**MITCHELL PARK HORTICULTURAL CONSERVATORY
DOMES
Peer Review**

Final Report

March 14, 2017

WJE No. 2016.2700

Figure 9. Section through hub from original drawings showing hub cladding drainage system

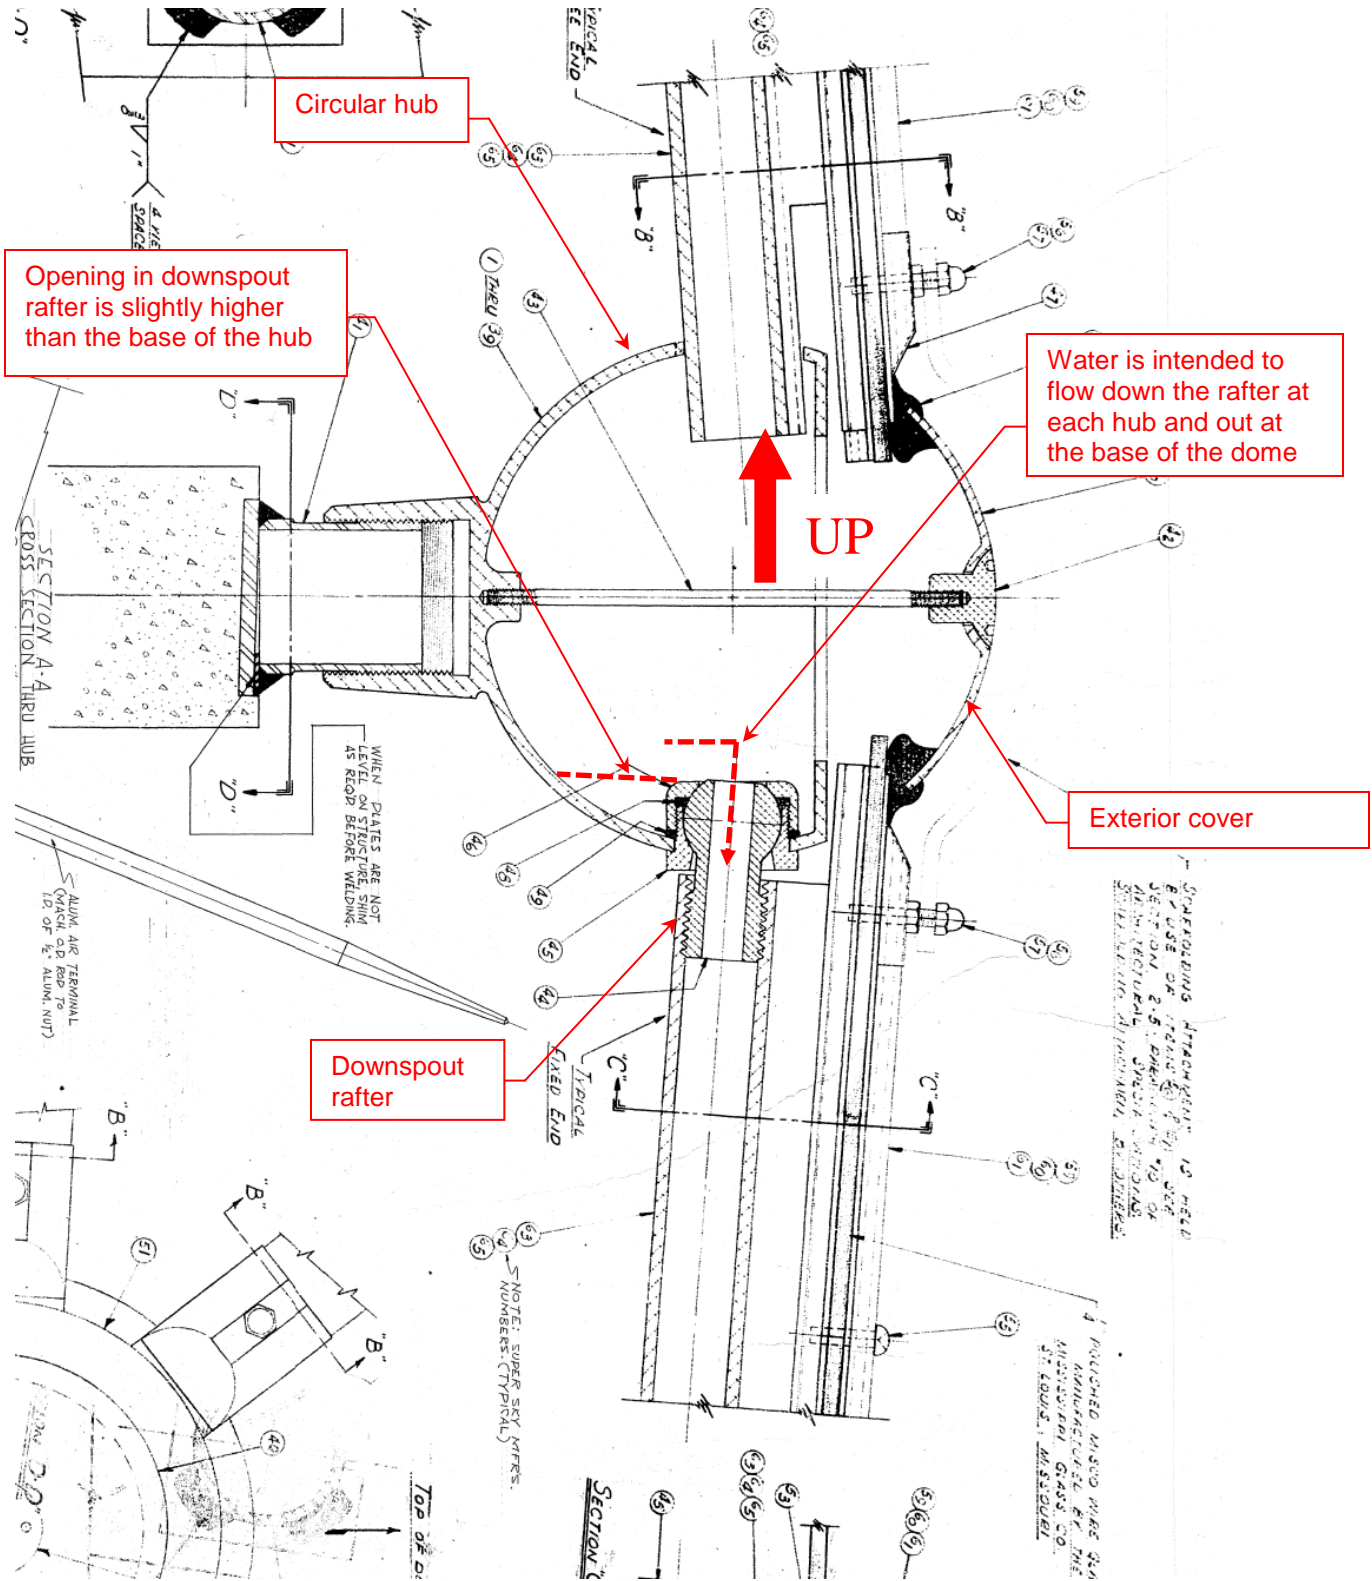
- GRAEF reported that water leakage throughout the domes has historically been a problem and still remains an ongoing issue. GRAEF reported that water was observed sitting in the hub and not allowed to drain. They attribute this problem as due to the fact that the downspout rafter extends higher than the base of the hub (see Figure 9).

Figure 24. Black build-up on downspout rafter fitting at water leakage location

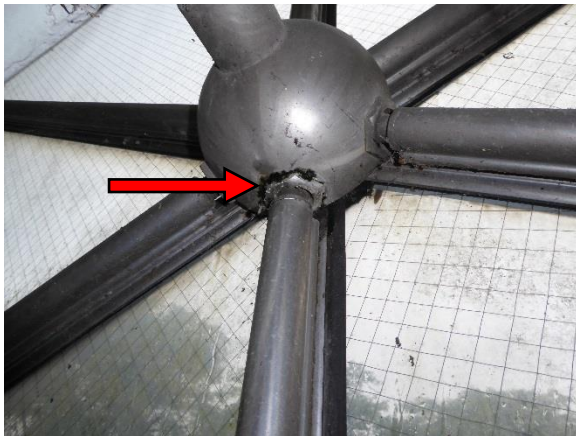
1. Cracked glass units were observed at several locations (Figures 20 and 21). Some of the cracked glass appears to be the result of impact.
2. The glazing material that separates the glass from the pressure caps has deteriorated over time. This is a likely source of water infiltration into the domes (Figure 22).
3. Sealant was installed around the hubs at several locations at the base of the domes (Figure 23).
4. Leakage was observed at approximately six locations in the Arid Dome at the connection of the hub to the downspout rafter. At locations where leaks were observed, the downspout rafter fitting had visible black material build-up, which seems to be an indicator of a leak location (Figure 24).

Figure 25. Section through glass and aluminum frame showing conceptual pressure cap repair for consideration

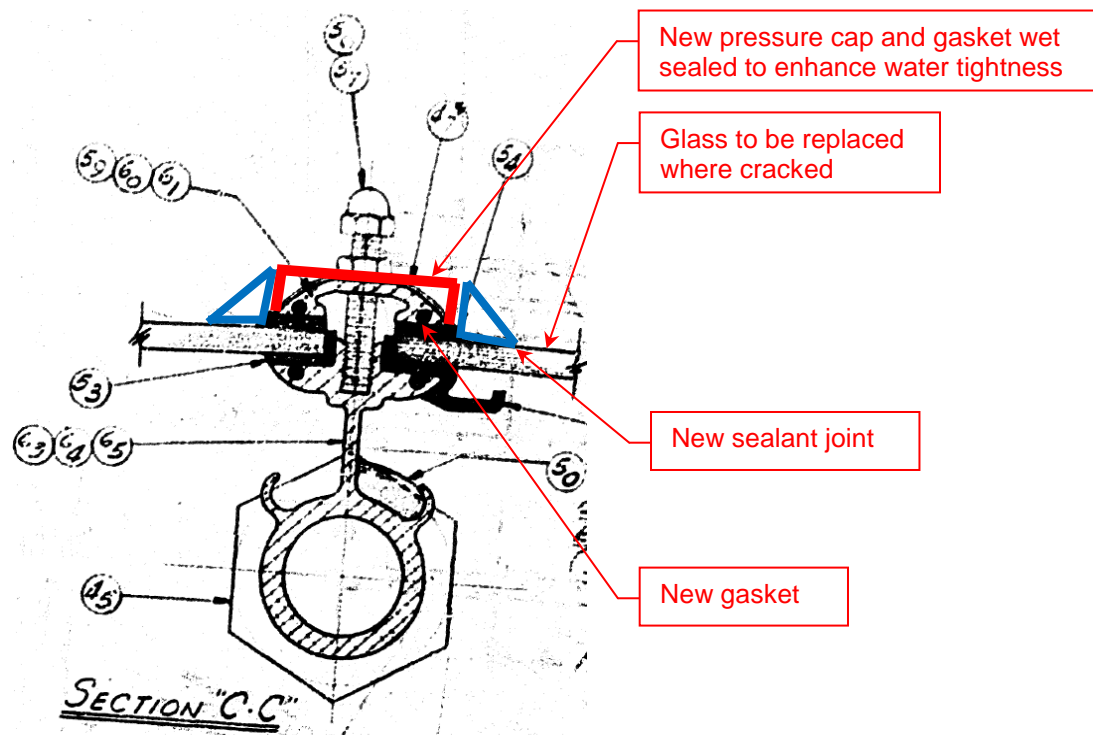
1. Replace existing cracked and broken wired glass in kind, or with laminated glass. Modifications in the glass replacement design could be implemented based on the findings from further investigation and mock-up repairs.
2. Remove and replace all pressure caps and wet seal joints (Figure 25).
3. Clean hubs and install self-leveling sealant at leading hubs (Figure 26).
